# RECORD PLANS

Contractor: DIRT TECH COMPANY, LLC  
 Resident Engineer: GREG WILCOX  
 Construction Began: AUGUST 25, 2017  
 Construction Complete: OCTOBER 23, 2018  
 Record Plans By: TAYLOR WARING & JESSE IVES

## PROPOSED IMPROVEMENT CITY OF SOUTH BURLINGTON COUNTY OF CHITTENDEN I-189 (PRINCIPAL ARTERIAL - INTERSTATE - NHS)

DIRECTOR OF PROJECT DELIVERY	
APPROVED:	DATE 4/19/2017
PROJECT MANAGER :	KEN UPMAL, P. E.
PROJECT NAME :	SOUTH BURLINGTON
PROJECT NUMBER :	IM SCR (21)
SHEET 1 OF 29 SHEETS

SCALE IN FEET STA. 62+75 TO STA. 63+00

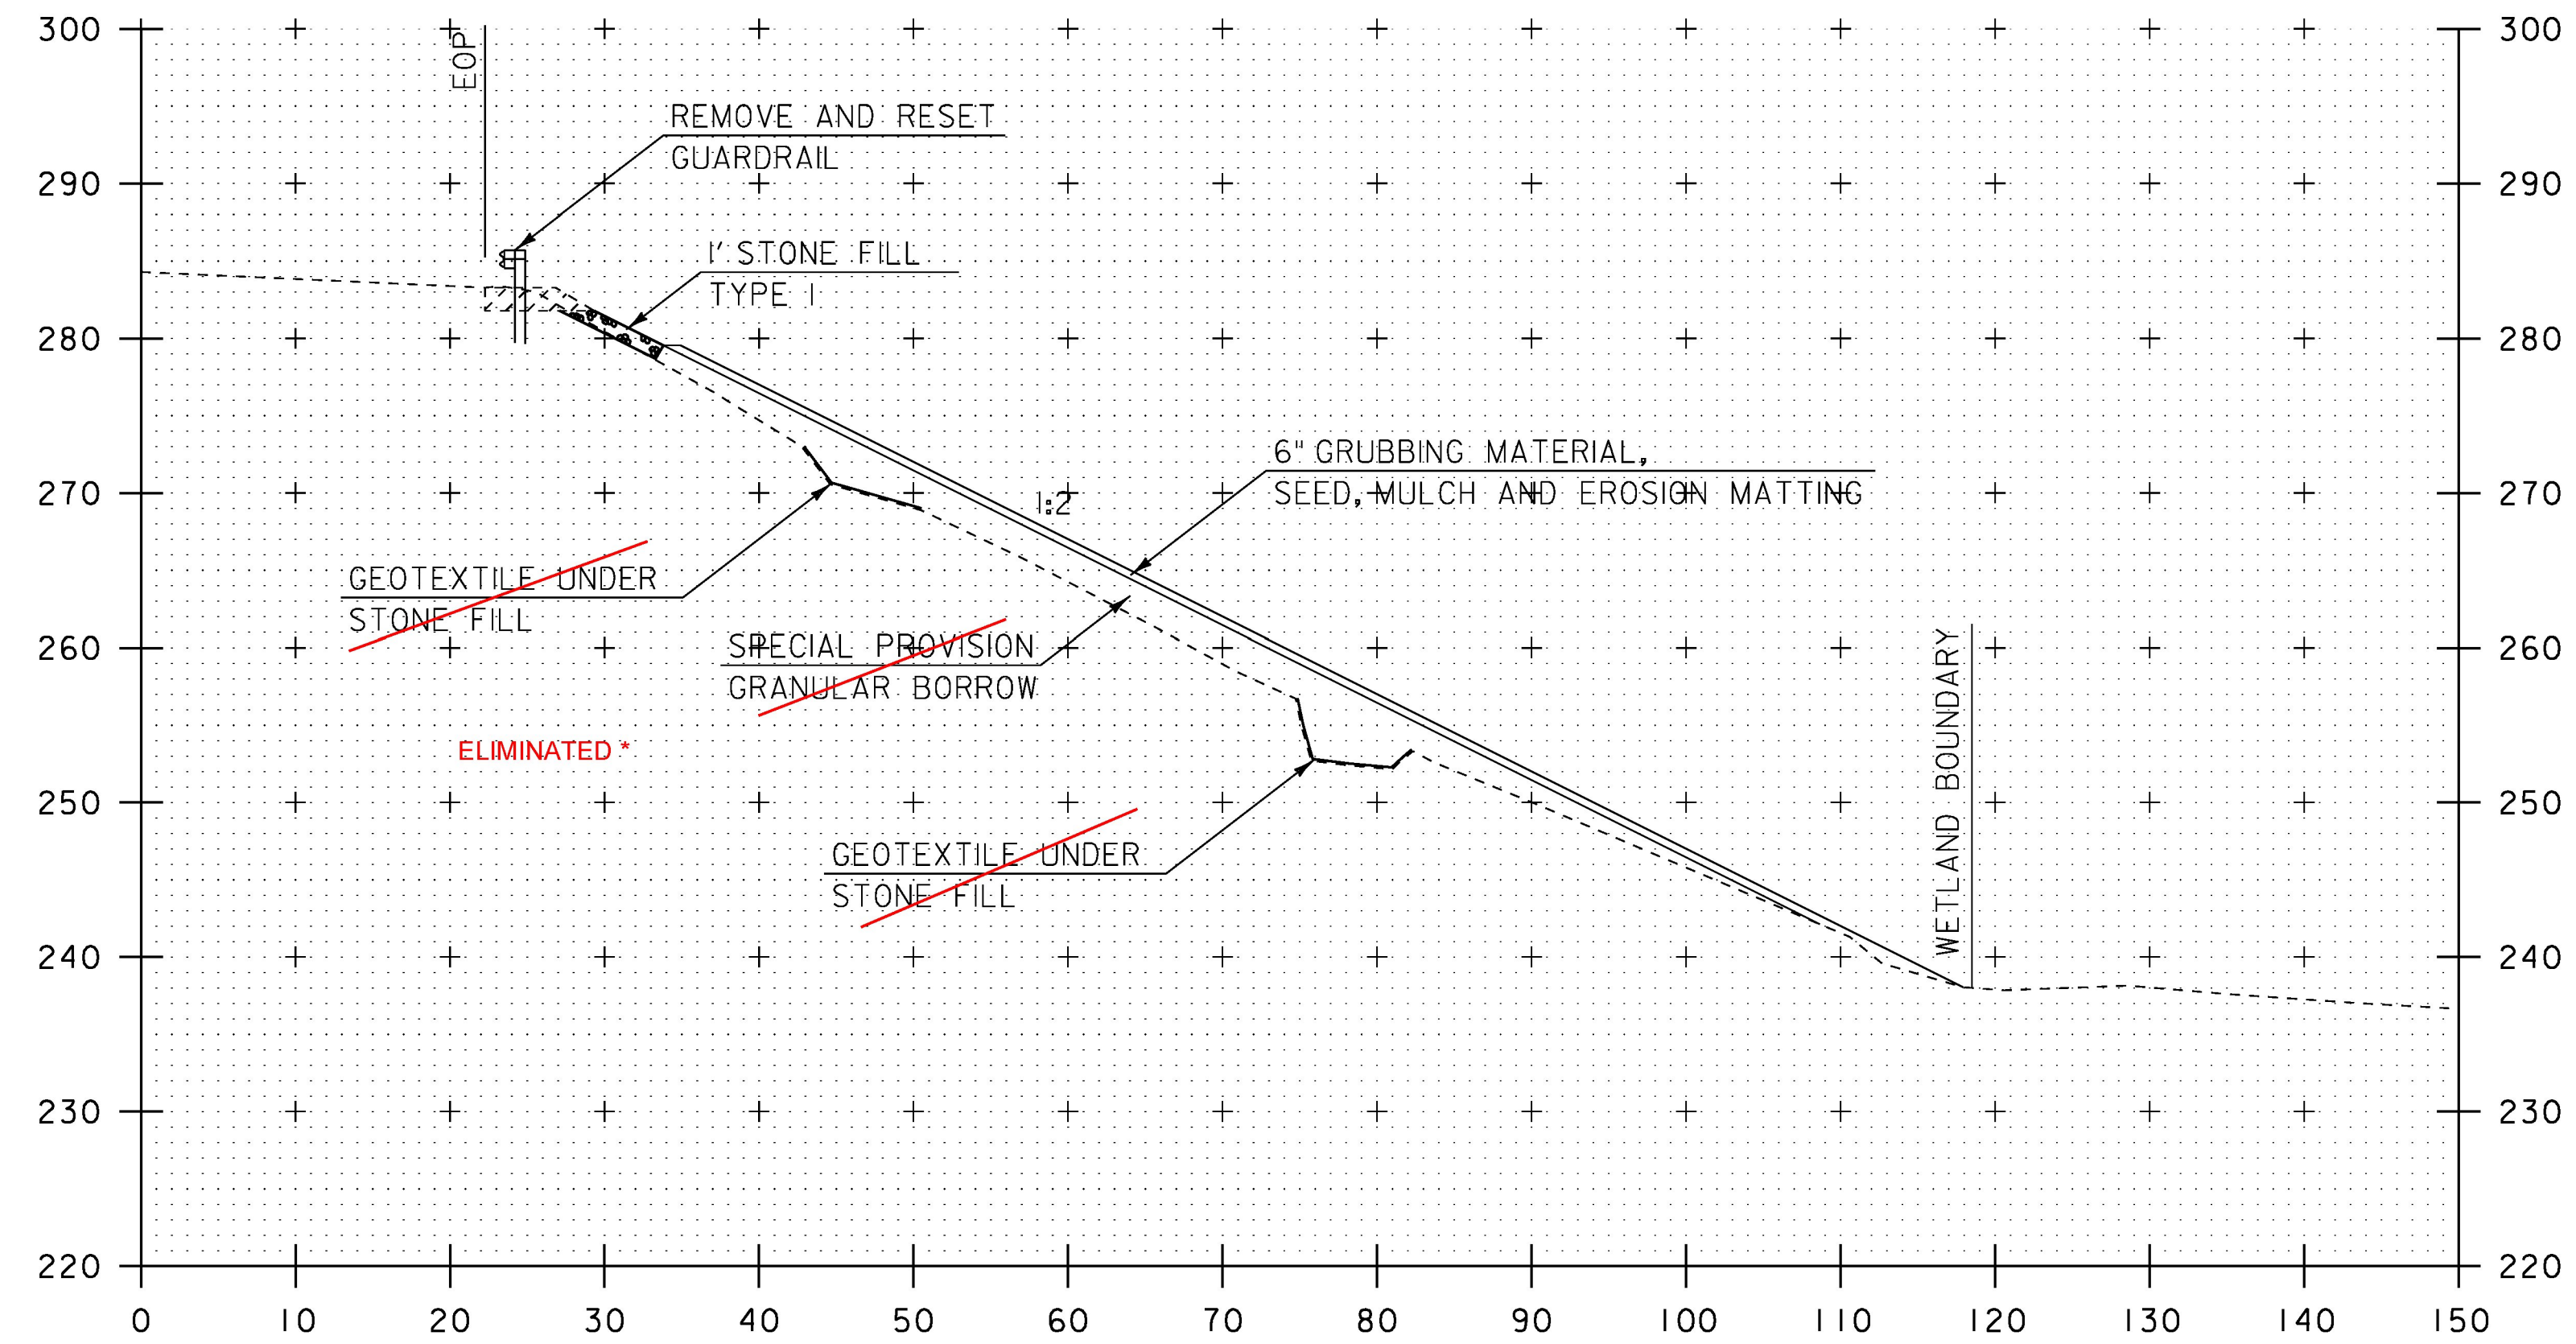
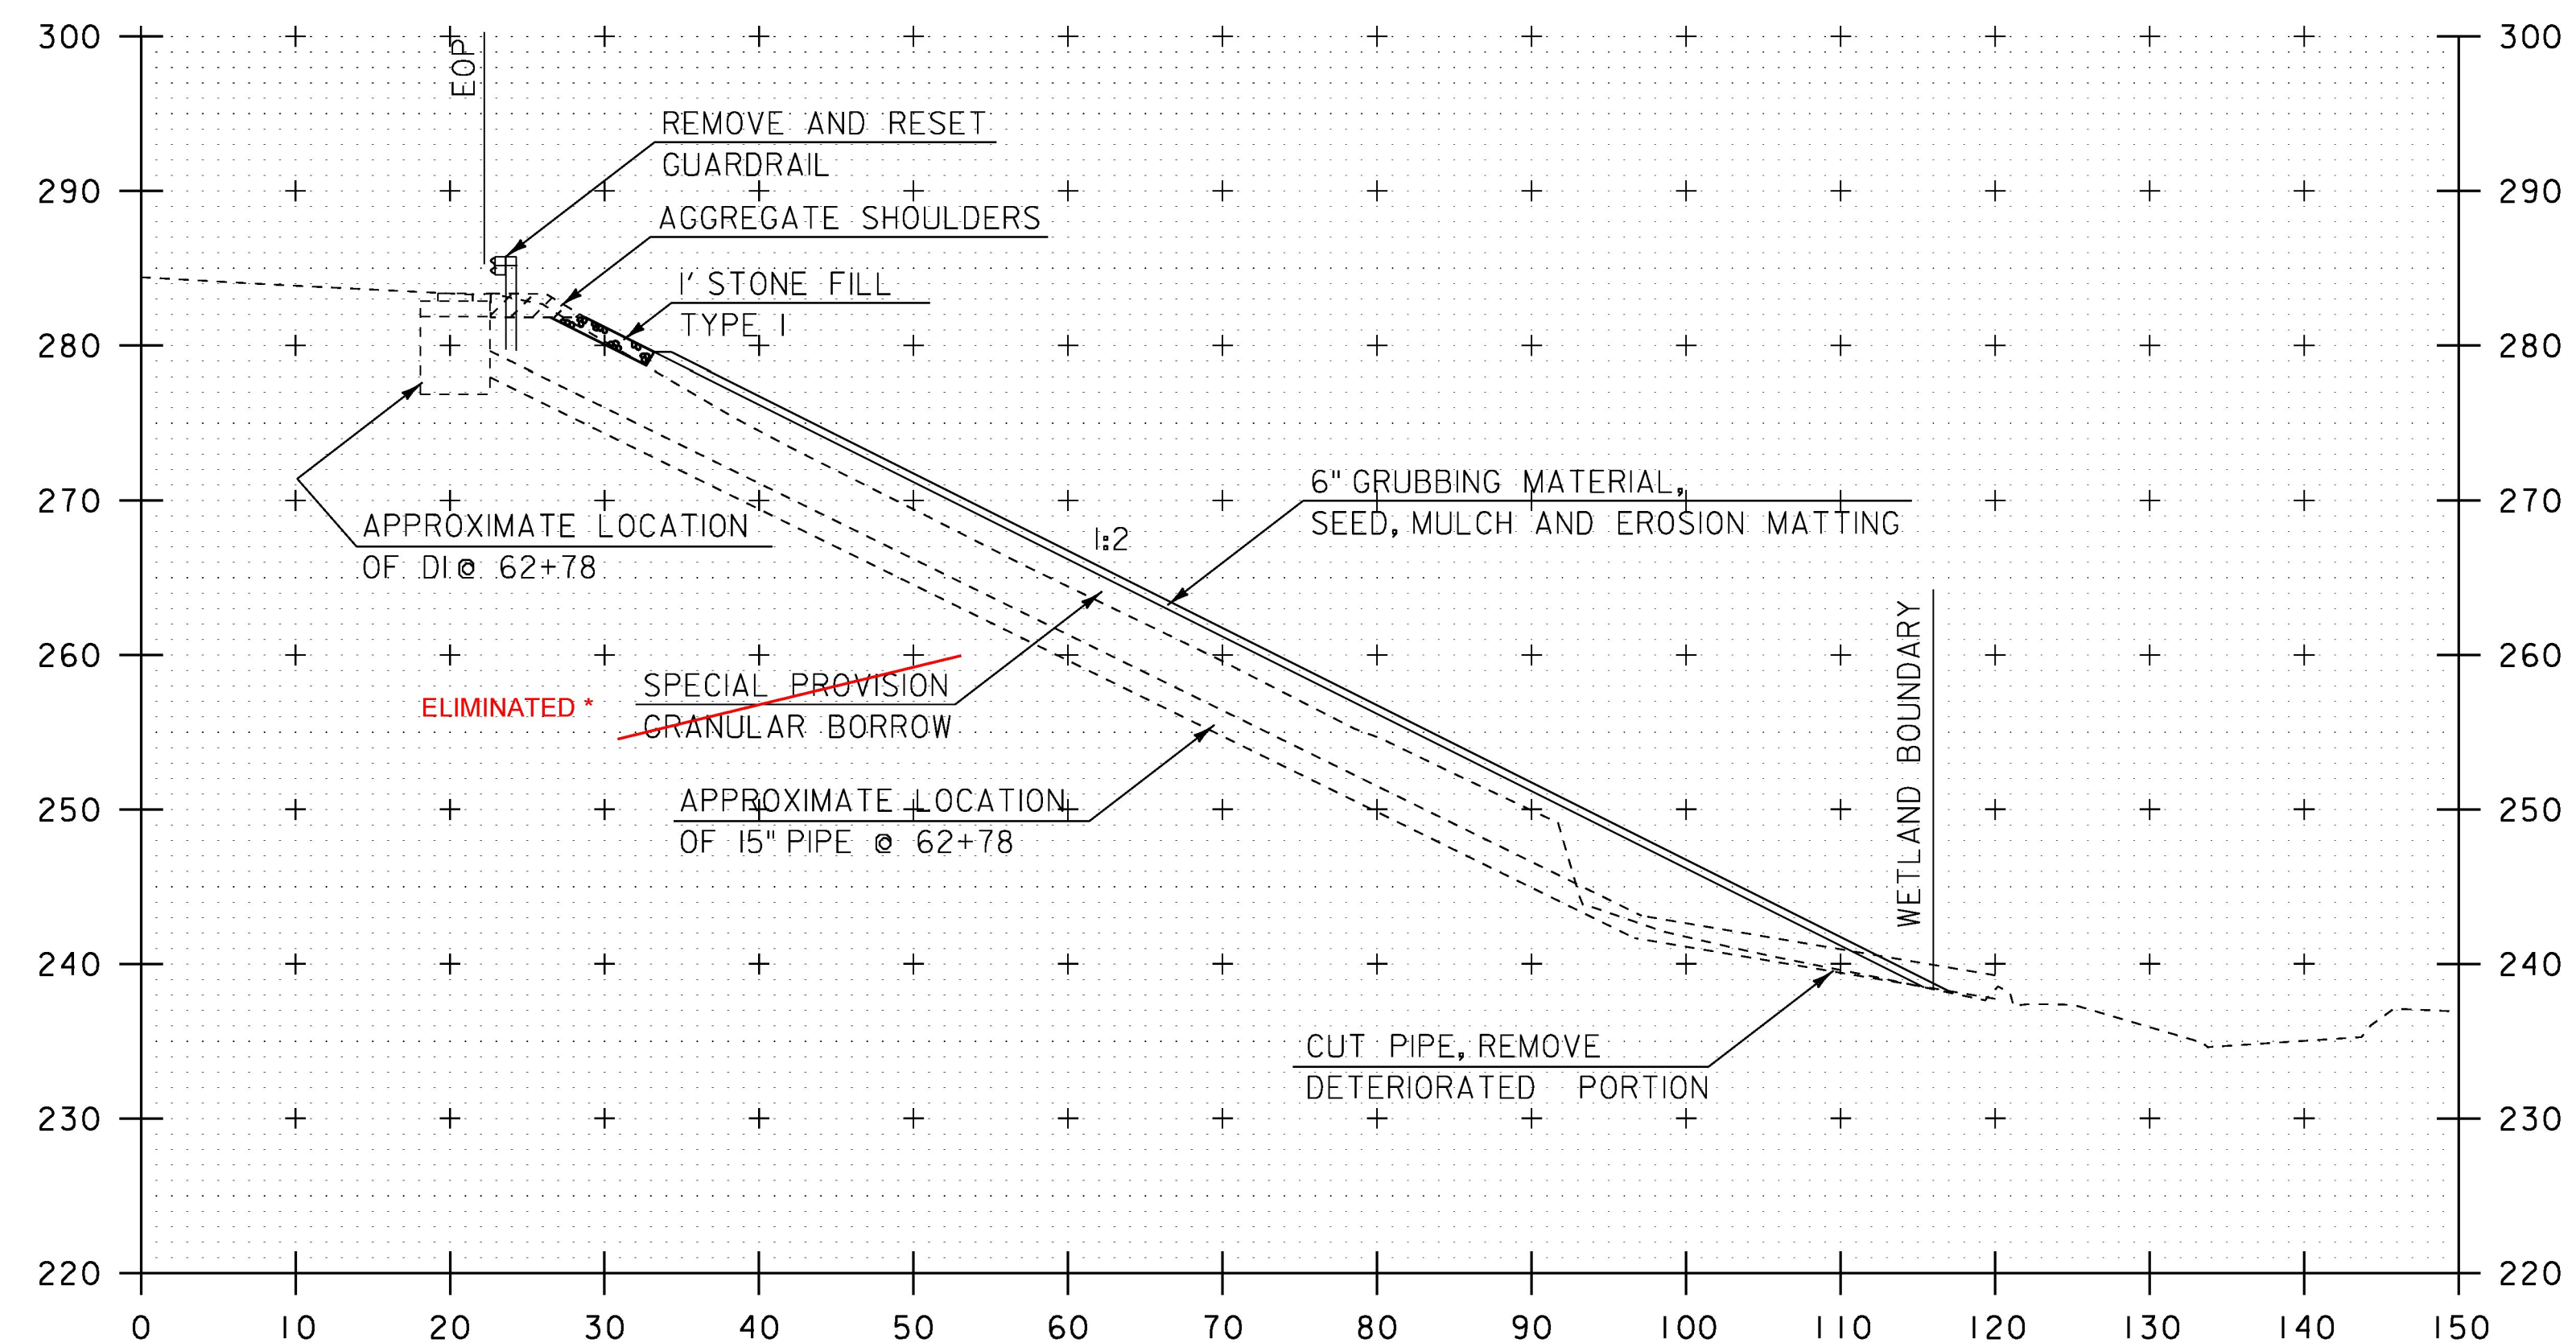
\* REPAIRS BY OPERATIONS ELIMINATED  
EMBANKMENT IRREGULARITIES, THEREFORE  
GRANULAR BORROW ITEM NOT USED
